**TO CONTRACT DOCUMENTS ENTITLED:**

**CHA Office Expansion + Renovation**  
201 Switzler St.  
Columbia, MO 65203

**ADDENDUM #2**

MEP2

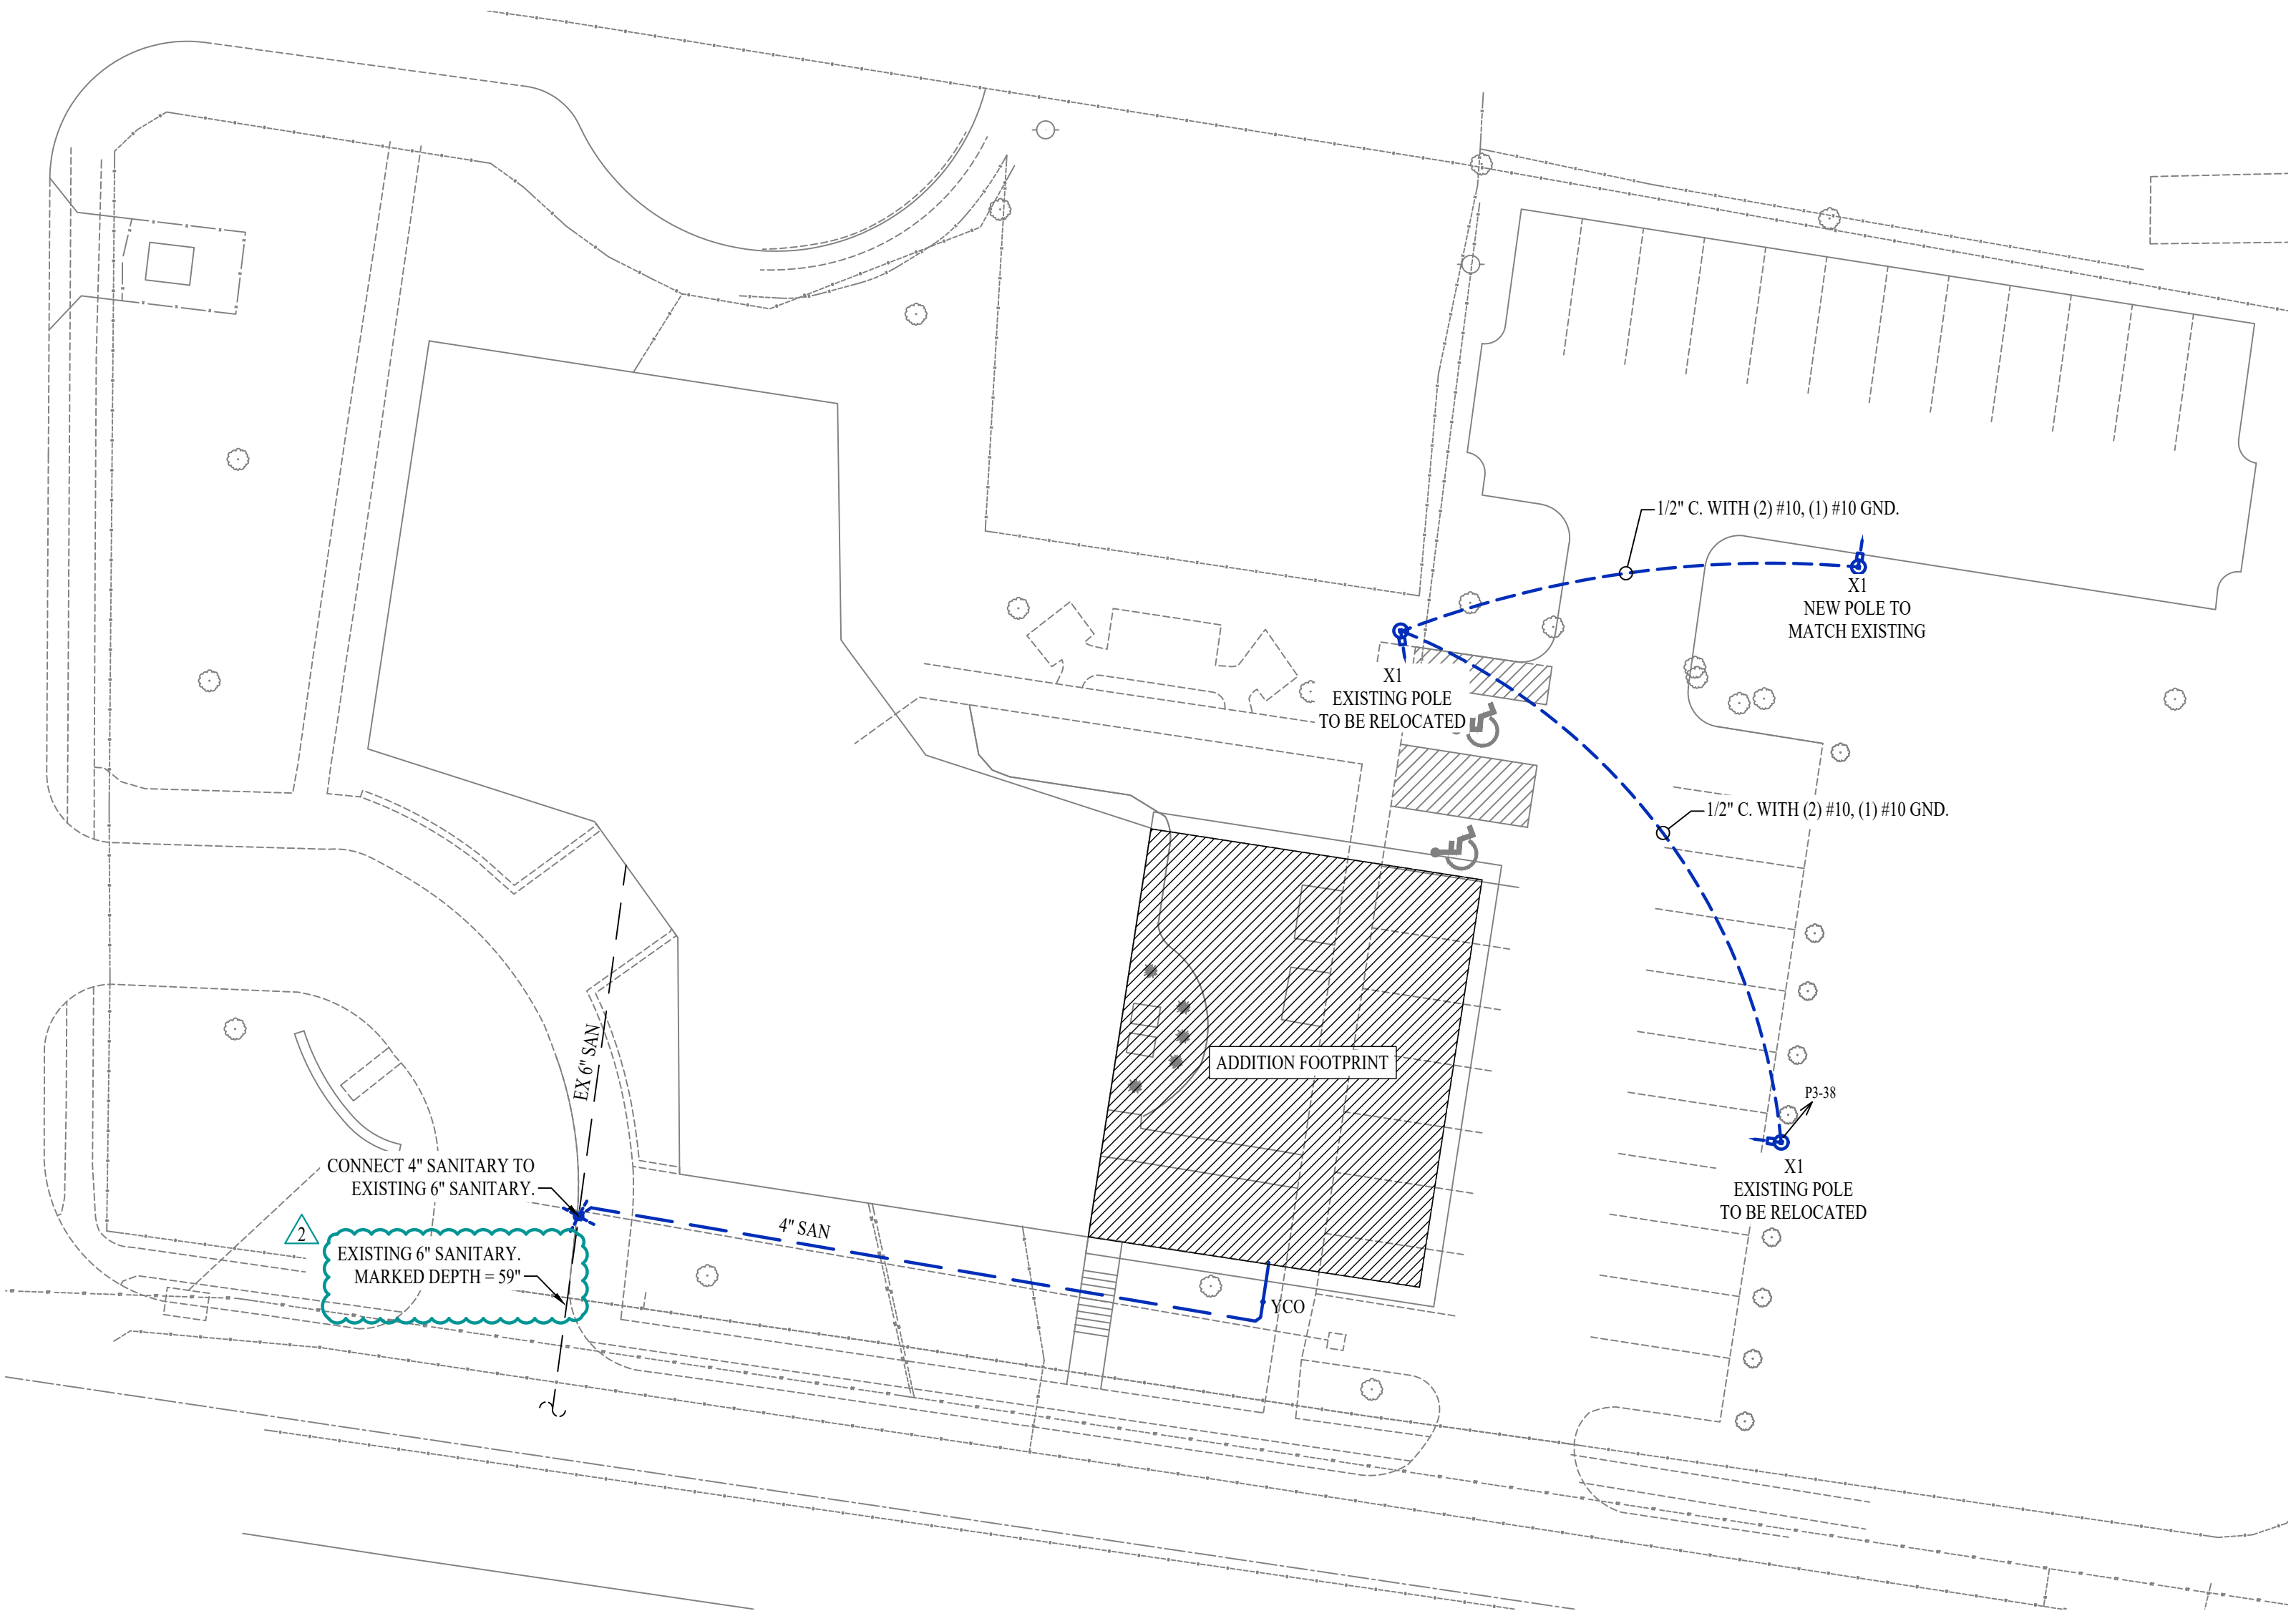
- 3) **MEP2 Site Plan:**
  - a) Clarification: The depth of the existing 6" sanitary sewer line at the new 4" lateral sanitary sewer tie-in location is 59". A note indicating this has been added to this sheet.
